store address  
 GOLDEN VALLEY  
 HATHERLEY LANE  
 CHELTENHAM  
 GL51 6TA  
 client: NNA Ltd

drawing title  
**PROPOSED**  
 SITE SIGNAGE PLAN

Drawing no.	FB ref.	revision
6406/2023/P121	2023/90	C

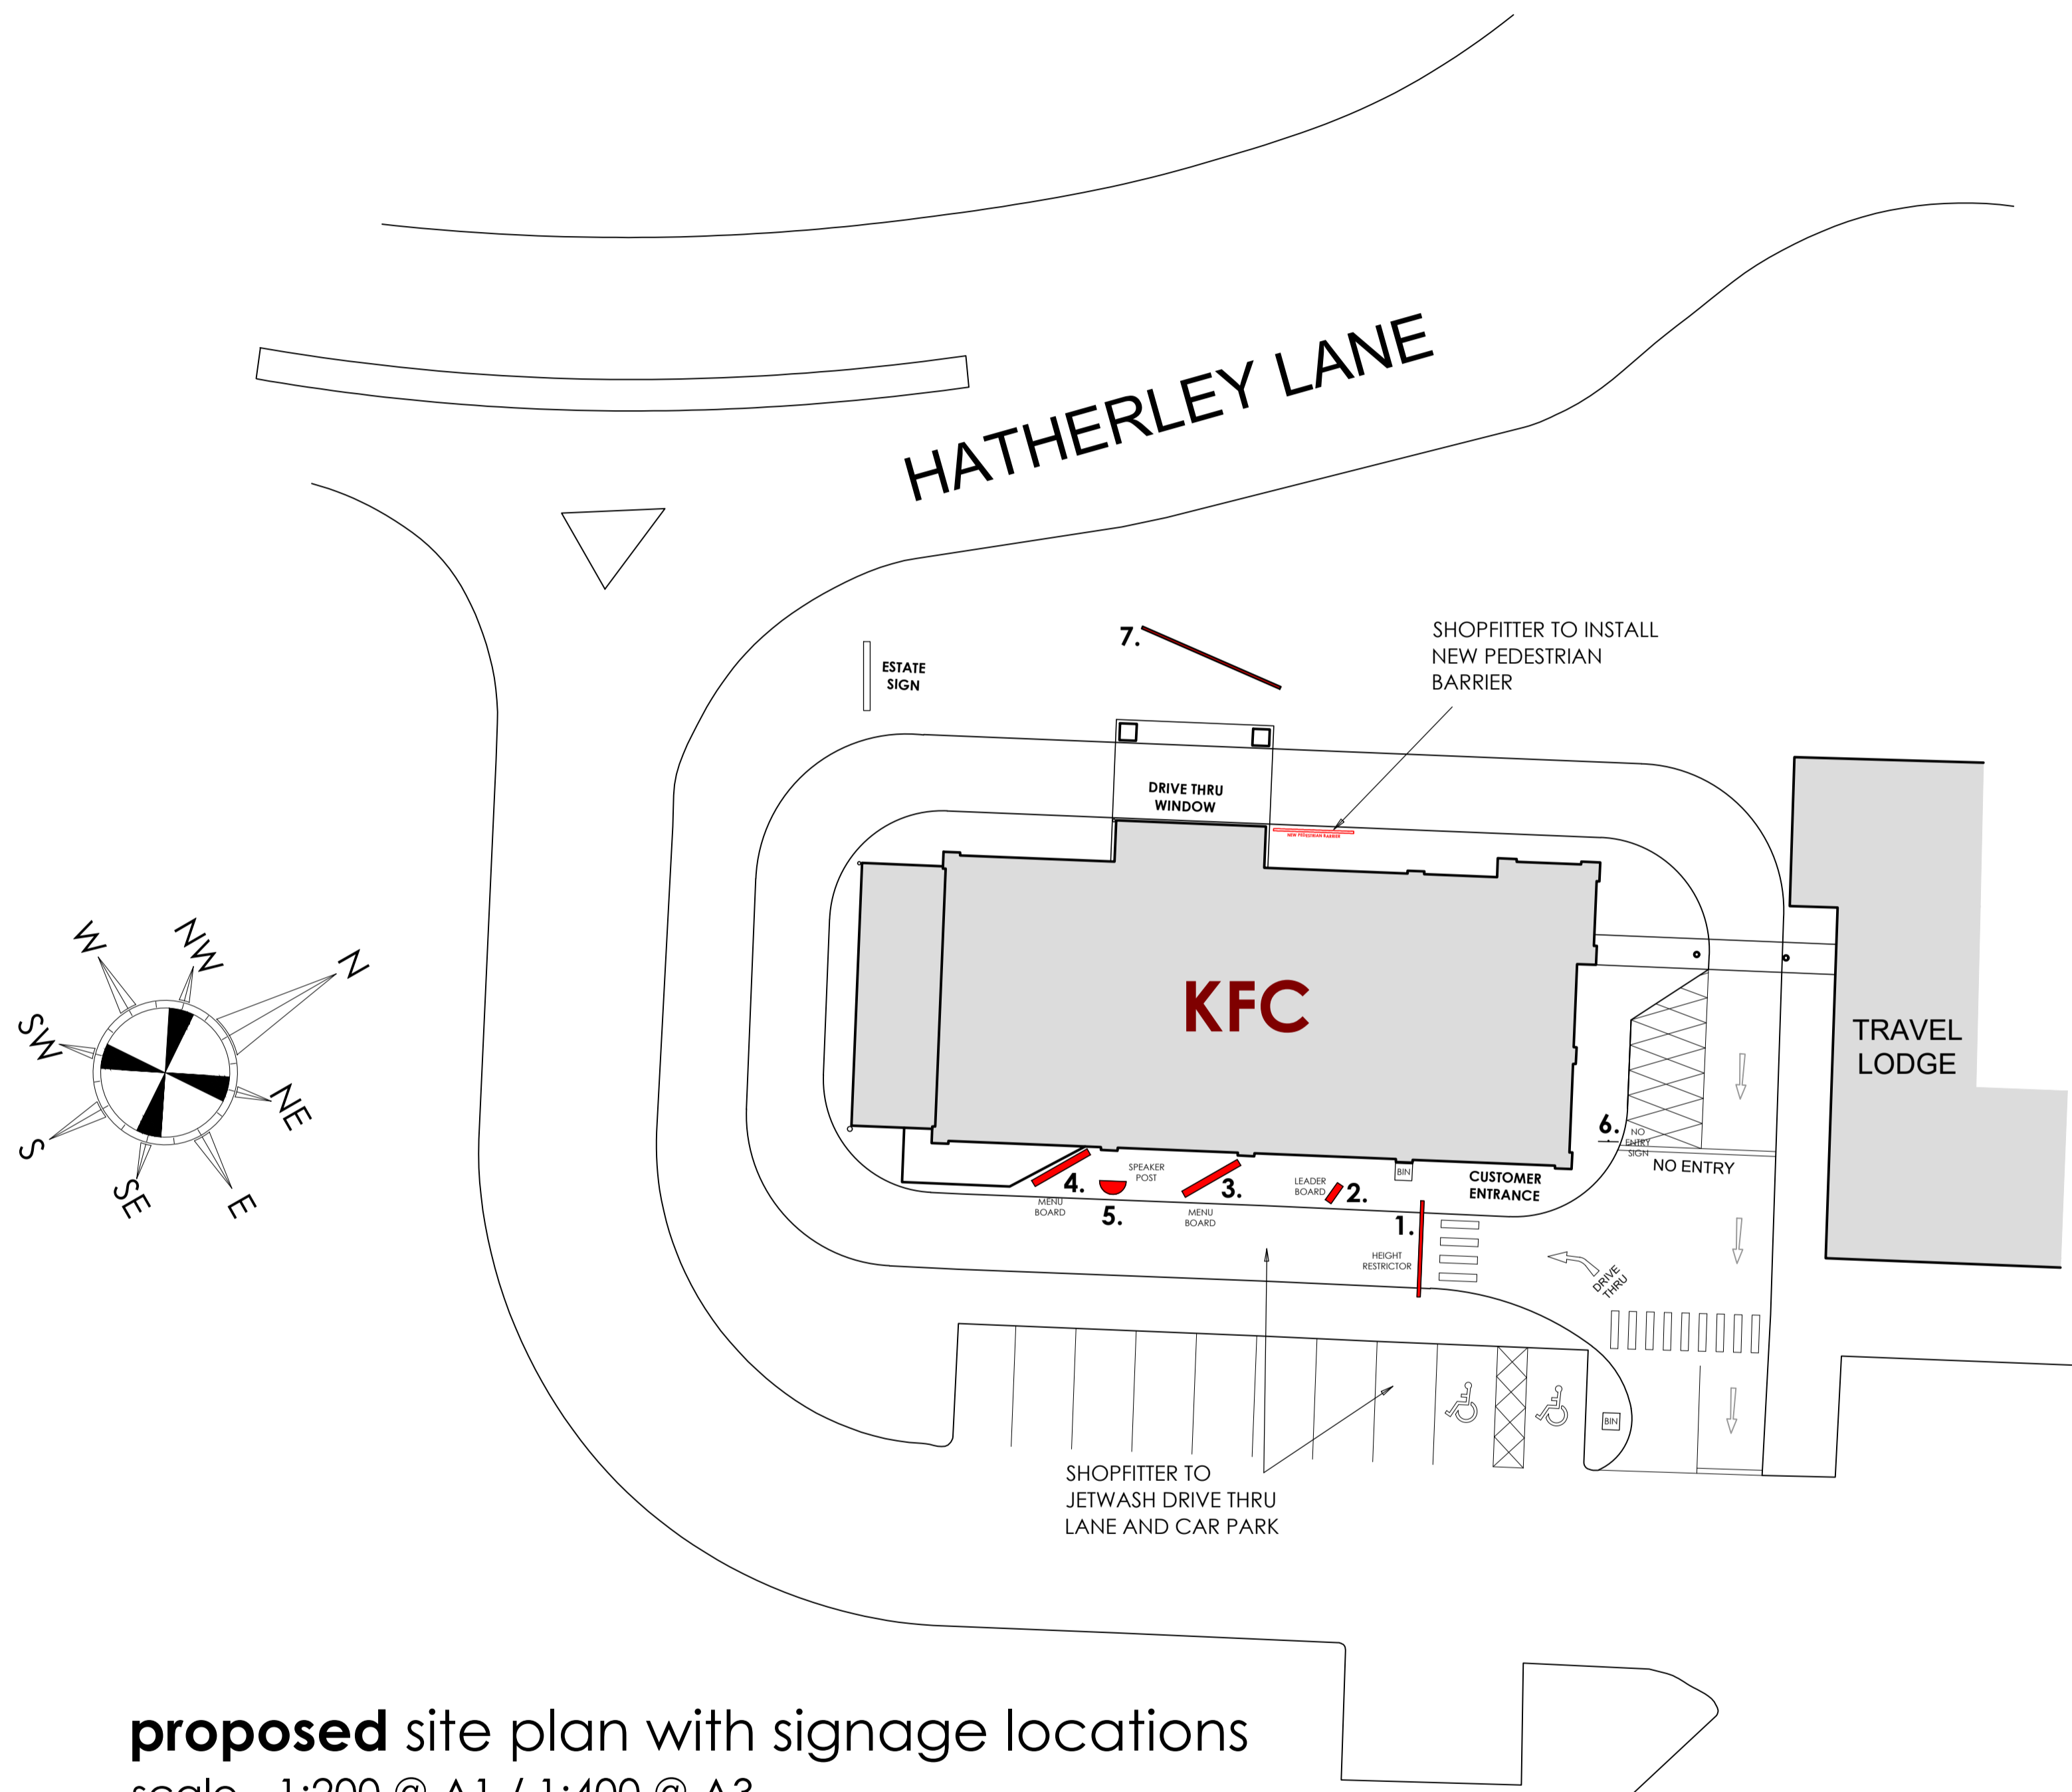
rev	date	description
C	04-12-23	Updated to suit KFC comments: height restrictor panel updated to latest spec; pole on no entry sign sprayed grey RAL 7022; banner frame to be sprayed black RAL 9005.
B	11-10-23	2nd leader swapped for 2nd menu as requested by KFC
A	10-10-23	New leader boards
